Remarks

Claims 1-17 are pending in the application.

FIG.1
PRIOR ART

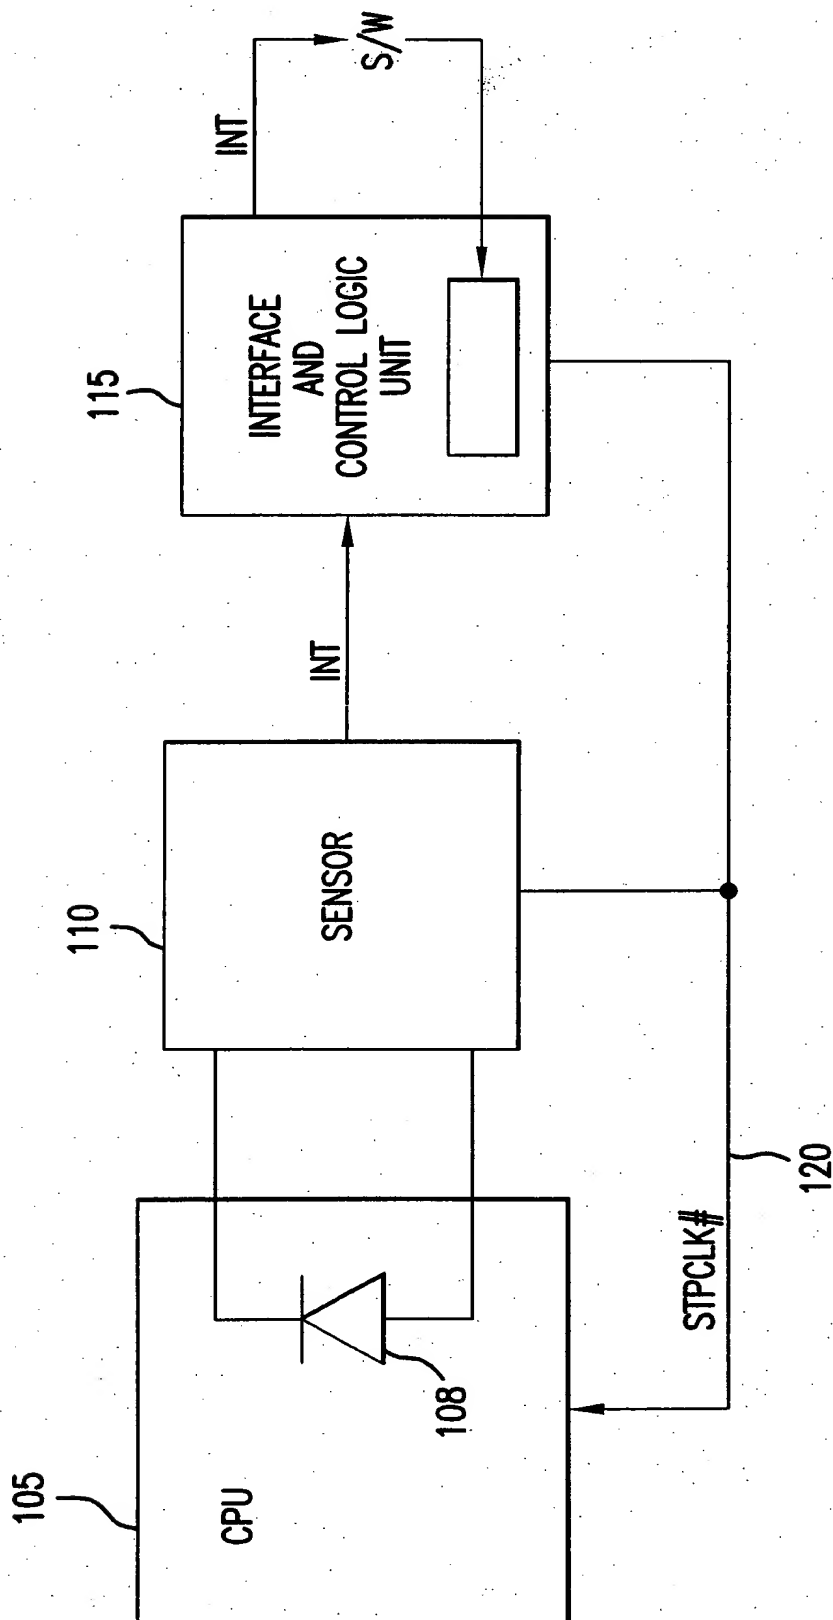
FIG. 1 was objected to. In accordance with the suggestion of the Office Action, the legend "PRIOR ART" has been added to FIG. 1. Withdrawal of the objection is therefore respectfully requested.

FIG.6

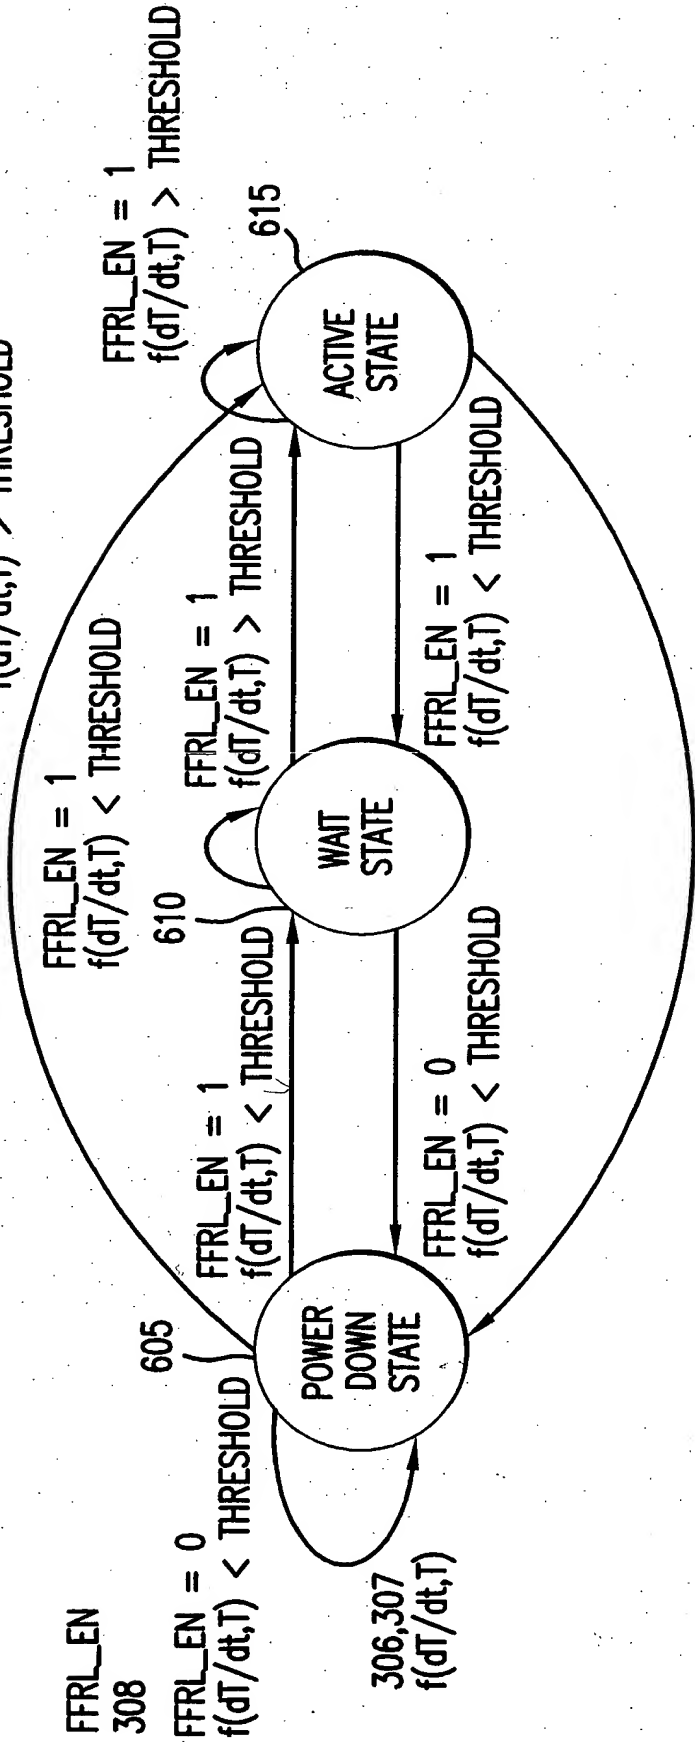
FIGs. 5 and 6 were objected to. Withdrawal of this rejection is respectfully requested in view of the amendment to FIG. 5 submitted herewith.

FIG. 6, though not objected to, has been amended to correct a minor informality noted therein.

Finally, concerning the objection to the specification in connection with the apparent inconsistency between the specification at page 13, lines 1-4, and FIGs. 5-6, the Applicant believes that the proposed amendment of FIG. 5 remedies the inconsistency. Withdrawal of this objection is therefore respectfully requested.
